INDESIT company

Model type:
DVG622IX

Commercial code:
F033223

Notices

N1045133/134FIG1

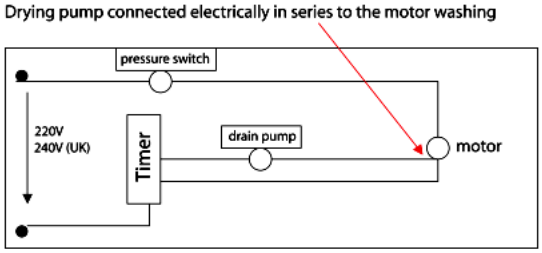
n1045133: New thermoprotected drain pump in parallel with wash electric pump

The drain pump electrical connection has been modified from a configuration in series with the wash electric pump to one in parallel.

The drain pump in series with the wash electric pump is fed through the wash electric pump causing a voltage drop equal to -15V (diagram N1045133-134FIG1).

Premodification parts:
Wiring in series
C00112306(Rohs 143739) - drain pump 230V 50HZ 22W - picture (N1045133-134FIG4)

The drain pump in series with the wash electric pump is electrically fed directly by the F-N line, without any voltage drop (diagram N1045133-134FIG1).

New parts:
Wiring in parallel
C00118767(Rohs 143766) - thermoprotected drain pump 220/240V 50HZ 26W - picture (N1045133-134FIG3)

Important!!
The thermoprotected drain pump cannot be installed on premodification dishwashers.
The non-thermoprotected drain pump cannot be installed on modified dishwashers.

N1045133/134FIG2

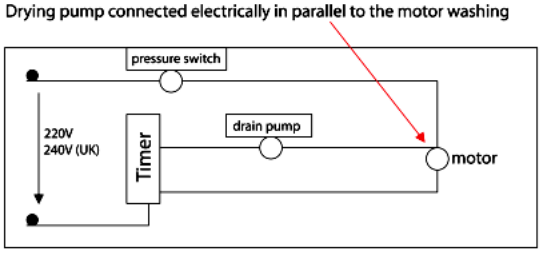
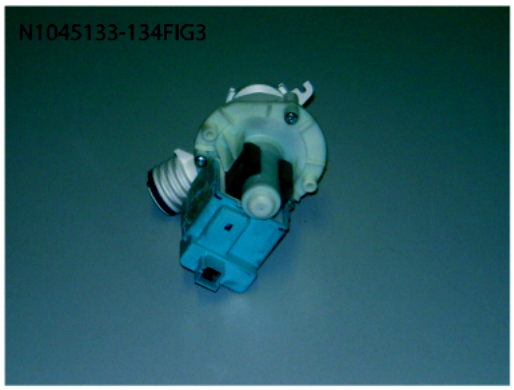
Drying pump connected electrically in parallel to the motor washing

N1045136FIG1

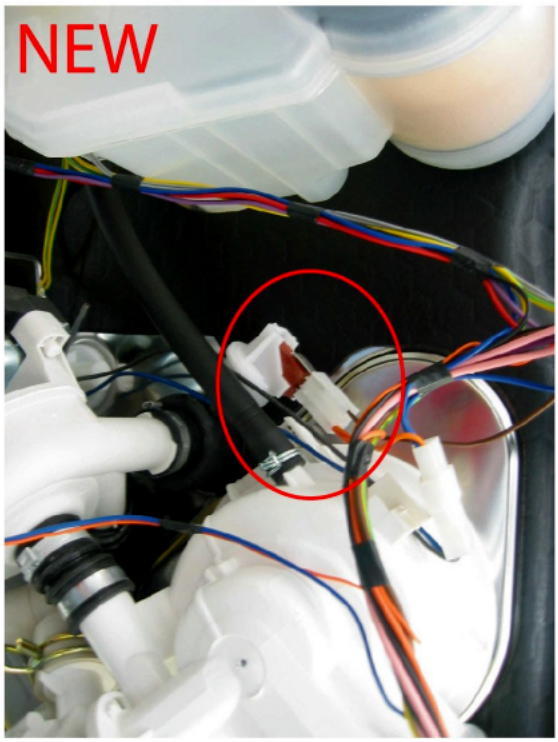
n1045136: introduction of new high pressure sensor

In modified products the connector going to the high pressure sensor is part of the wiring assembly (see picture N1045136FIG1).
In premodification products the high pressure sensor is connected to the wiring assembly by a cable that is part of code C00094157 (see pictures N1045136FIG2-3).

New parts
Wiring
C00142435 - high pressure sensor

The new parts are not individually interchangeable with premodification ones.

N1045136FIG2

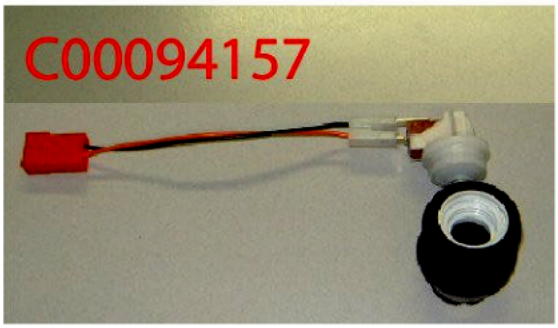
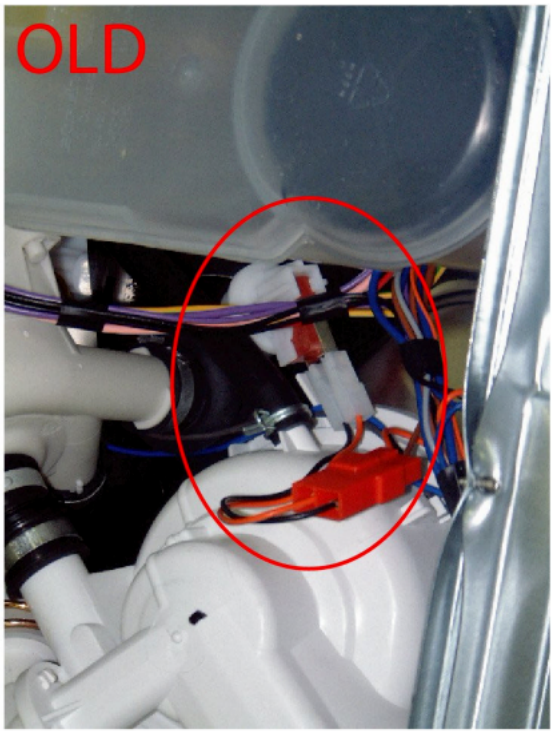
Premodification parts
Wiring
C00094157 - high pressure sensor + cable
